# Access Compliance Report Public Rights-of-Way (Curb Ramps)

Intersection ID: 15215	Main Street: HARRISBURG_RD	Cross Street: OLD_MEADOW_RD	Location: SW
ADA ID: FEC56767B5AD	Ramp Type: PerpDiag	Initial Pass/Fail: Fail	Overall Compliance: No Severity Score: 12.5

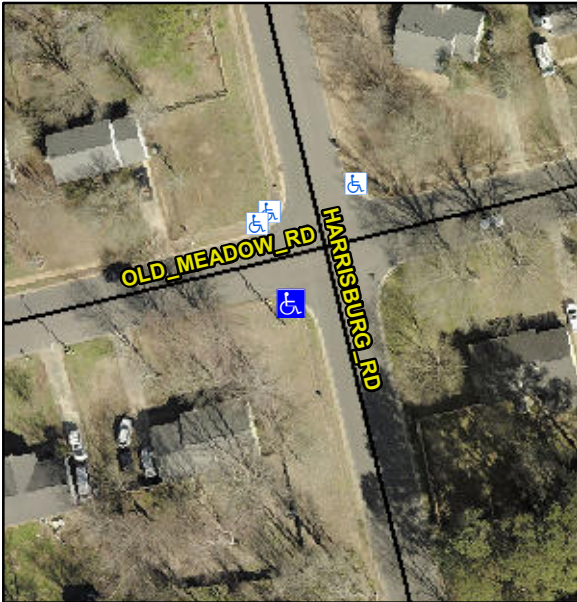
Compliance	Description	Data	Compliance	Description	Data
N/A	Ramp Length (in)	84.0	No	Ramp Slope (%)	8.8
Yes	Ramp Width (in)	48.0	Yes	Ramp XSlope (%)	1.7
N/A	Flare Type LT	N/A	N/A	Flare Type RT	N/A
N/A	Flare Slope LT (%)	N/A	N/A	Flare Slope RT (%)	N/A
N/A	Flare Traversable LT?	N/A	N/A	Flare Traversable RT?	N/A
N/A	Landing Length (in)	N/A	N/A	DWS Provided?	N/A
N/A	Landing Width (in)	N/A	N/A	DWS Contrast?	N/A
N/A	Landing Slope (%)	N/A	N/A	DWS Length (in)	N/A
N/A	Landing X Slope (%)	N/A	N/A	DWS Full Width?	N/A
N/A	Landing Curb? (Y/N)	N/A	N/A	DWS Offset (in)	N/A
N/A	Shared Landing?	N/A			
N/A	Gutter Ponding?	N/A	N/A	Gutter Slope (%)	N/A
N/A	Gutter Lip Ht (in)	N/A	N/A	Gutter X Slope (%)	N/A
N/A	Painted X Walk1?	No	N/A	Painted X Walk2?	No
	X Walk 1 Direction	To E		X Walk 2 Direction	To N
N/A	X Walk 1 Width (in)	N/A	N/A	X Walk 2 Width (in)	N/A
	X Walk 1 Slope (%)	4.3		X Walk 2 Slope (%)	4.8
	X Walk 1 X Slope (%)	4.2		X Walk 2 X Slope (%)	4.9

N/A	Ramp inside XWalk1?	N/A	N/A	Ramp inside XWalk2?	N/A
	Road Slope (%)	1.0	N/A	Clear Space?	N/A
	Road X Slope (%)	6.2	N/A	Clear Space to XWalk (in)	N/A
N/A	Any Obstructions?	N/A	N/A	Storm Grate/Utility Hazard?	N/A
	Obstruction Type			Storm Grate/Utility Type	
			N/A		N/A
			Yes	Surface Condition? (G/P)	Good

Possible Solutions:  
**Remove & Replace Curb Ramp With Two New Directional Ramps or Equivalent.**

**R304.2.2**
